CAMPAIGN BULLETIN

Subject: **Campaign 07C-2**
Sterling 360 EGR Crossover Pipe

Figure 1

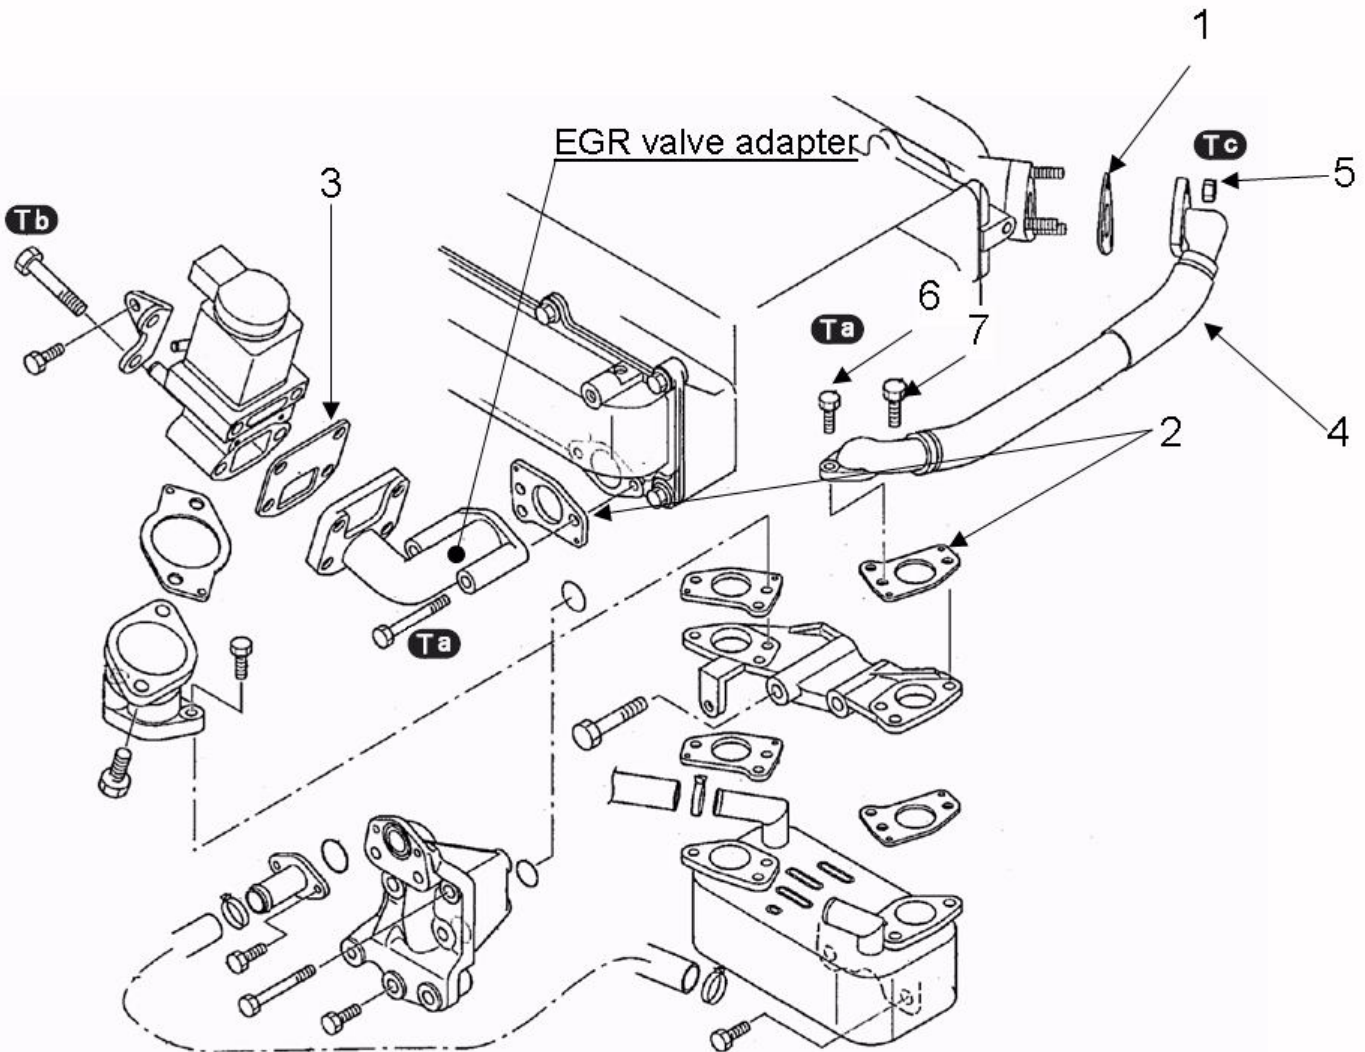
Detroit Diesel has determined that on affected Sterling 360 engines the the EGR crossover pipe may develop cracks and release uncatalyzed exhaust gases in to the atmosphere.

Replacing the EGR crossover pipe with an improved component will result in reduced thermal strain and bring them into compliance with U.S. EPA emissions regulations and prevent customer dissatisfaction.

2. EGR pipe replacement:
 - a. Remove EGR valve adapter.
 - b. Remove EGR pipe.
 - c. Install new EGR pipe with new gaskets, bolts, and nuts. Torque fasteners.
 - d. Install EGR valve adapter with new gaskets. Torque fasteners.

Callout	Item	Torque
1	Gasket EGR pipe	-
2	Gasket EGR (use 2, discard 1)	-
3	Gasket EGR valve B	-
4	Pipe, EGR, A	-
5	Nut, flange (exh manifold to EGR pipe)	-
6	Bolt, flange (8x40mm) (EGR pipe to cooler)	-
7	Bolt, flange (8x50mm) (EGR pipe to cooler)	-
Ta	Torque to	17 ft.lbs
Tb	Torque to	33 ft.lbs
Tc	Torque to	15 ft.lbs
